Subject: Saxton Nuclear Experimental Corporation (SNEC)
SNEC License Termination Plan (LTP), Response to NRC Request for
Additional Information
Operating License No. DPR-4
Docket No. 50-146

Response to Request for Additional Information, RE: License Termination Plan, (TAC
NO. MA8076) dated January 17, 2001

**RESPONSE TO NRC REQUEST FOR ADDITIONAL INFORMATION
GPU NUCLEAR - SAXTON NUCLEAR EXPERIMENTAL CORPORATION
DOCKET No. 50-146, LICENSE No. DPR-4**

HYDROGEOLOGIC CROSS SECTION A-A'

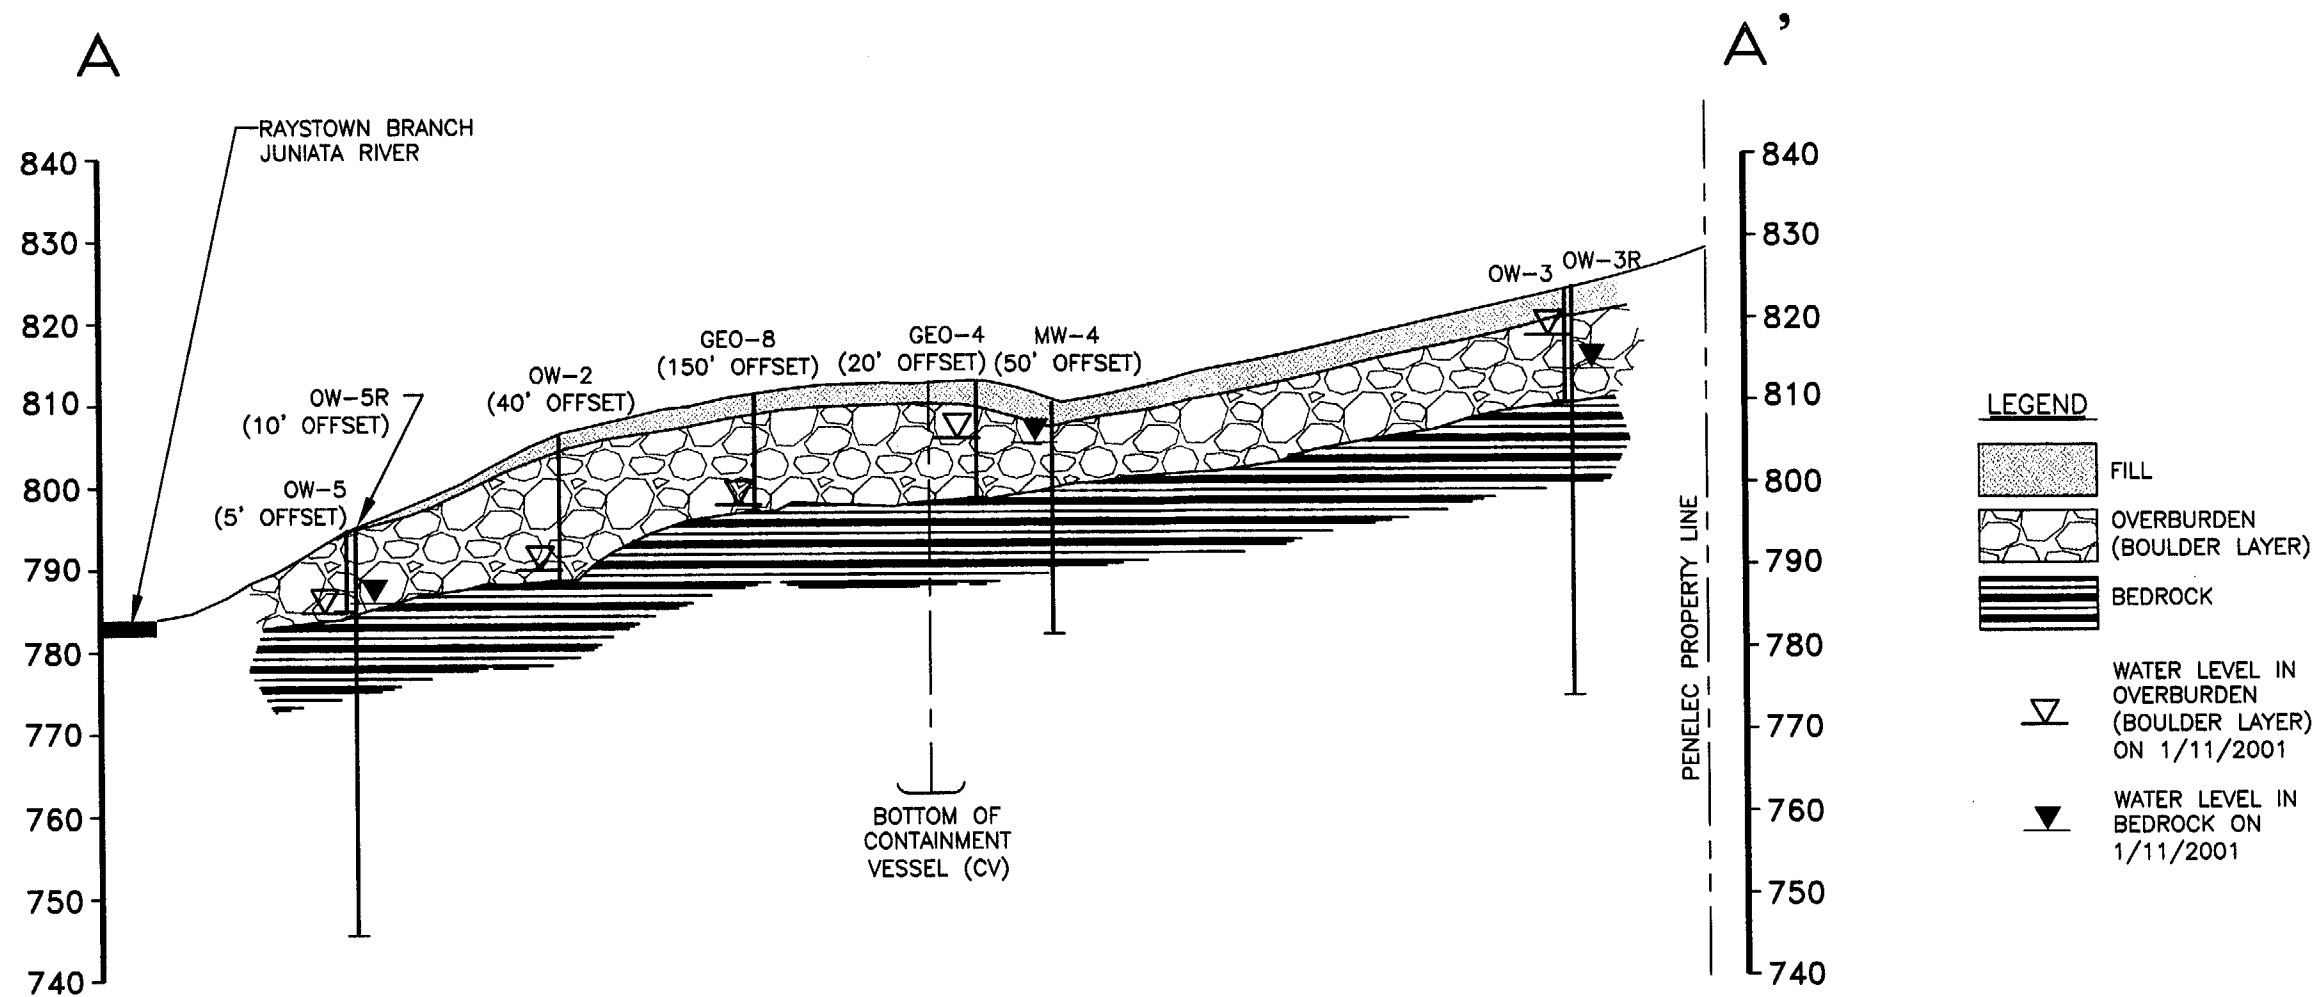
2. "The following items should be determined and provided to the NRC: (1) current water level configuration maps representing the shallow water bearing unit (wells screened in the fill, boulder, and the upper weathered bedrock) and the bedrock water bearing unit (wells screened in the bedrock at a depth approximately equal to the base of the CV); (2) ground water flow patterns for both water units delineating discharge points; (3) ground water flow rates with and without dissolved radionuclides; (4) whether radionuclide contaminated ground water has either reached surface water discharge points or moved beyond the SNEC property; and (5) hydrogeologic cross sections delineating the lithology, and potentiometric surfaces across the site."

(5) Hydrogeologic cross sections delineating the lithology, and potentiometric surfaces across the site: see section 3.0 "GROUND WATER FLOW" and figures 2,4, 5, 7 and 8 of the Haley & Aldrich report.

Water level elevations in the overburden and the bedrock wells show the Raystown Branch of the Juniata River is a discharge point for groundwater from the facility. Referring to Figure 5 (A-A'), it is apparent that water levels are higher to the east (A') and generally decrease to the west (A) and the river. Further, the water level in the overburden well OW-3 compared to its counterpart in the bedrock (OW-3R), indicate groundwater in the overburden has the potential to replenish the bedrock. On the left-hand of the drawing the water level in the rock is higher than the river, indicating that the groundwater drains to the river. Figure 5, on the right-hand side of this hydrogeologic cross-section (near B'), the overburden well is dry and groundwater flow is taking place in the bedrock (through openings in the rock), draining to the river (note the water level is higher in the bedrock well than the river). These same flow patterns are on the other side of the Raystown Branch of the Juniata River and regional groundwater flow is shown in Figure 9. The relationships described above maybe affected by seasonal water level fluctuations.

NOTE: SCHEMATIC OF GROUNDWATER MONITORING WELL (GEOMON). REFER TO ACCOMPANYING WRITTEN DESCRIPTION.

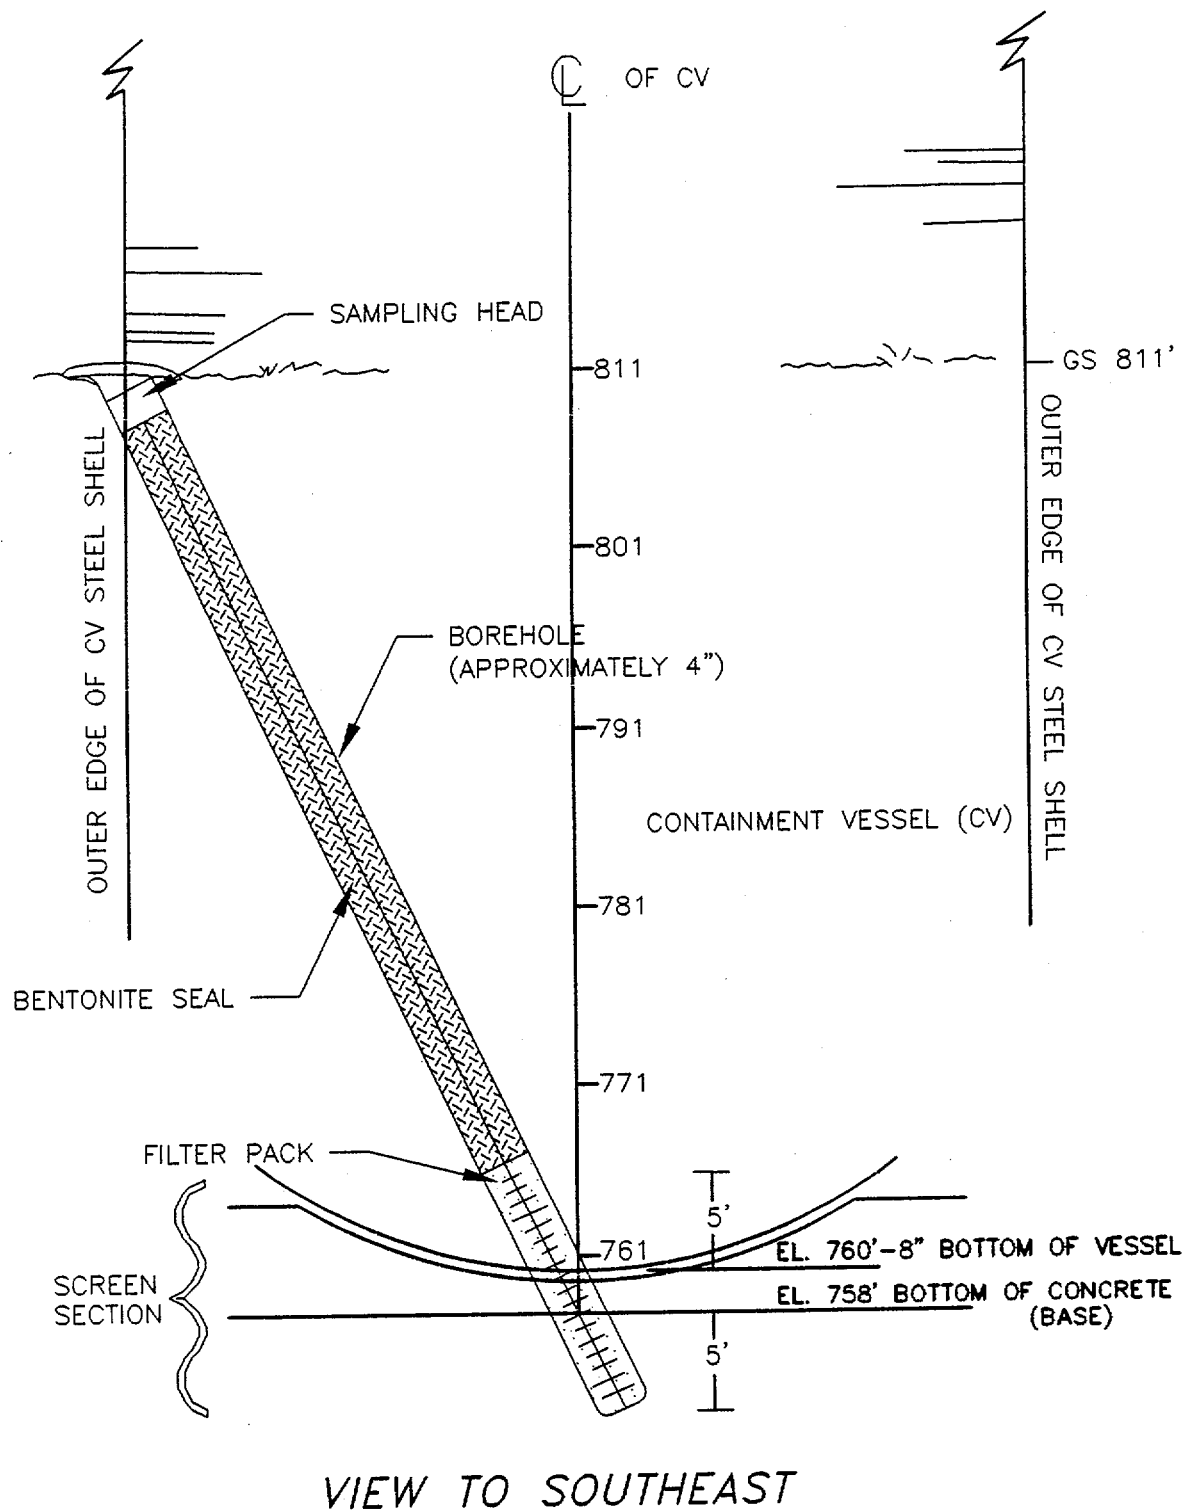
Based on the teleconference conducted on December 6, 2000, the NRC staff understands that GPU Nuclear proposes to install at least one bedrock monitoring well (during the spring or early summer 2001) hydraulically down gradient but adjacent to the CV. This monitoring well will be installed so that its screened interval will range from 5 feet above to 5 feet below the CV concrete base. GPU Nuclear intends to add this monitoring well to their modified schedule for sampling radionuclides and measuring water levels. Please confirm GPU Nuclear's proposed plan to add this monitoring well, as discussed on December 6, 2000, and provide this detailed plan to the NRC for review.

- ☐ Install this monitoring well approximately 15' hydraulically down gradient from the CV.
- ☐ Install monitoring well in a bedrock angle drillhole (25 degrees). The screen section should effectively extend five feet above the bottom of the CV shell and five feet below the concrete base see Figure 10 (attached).

- ☐ A GEOMON groundwater-sampling device should be utilized since this device is currently in use on site and its smaller diameter provides more options for filter design. A general schematic of the GEOMON, showing the screen section in relation to the base of the concrete, is presented on Figure 10 (attached).
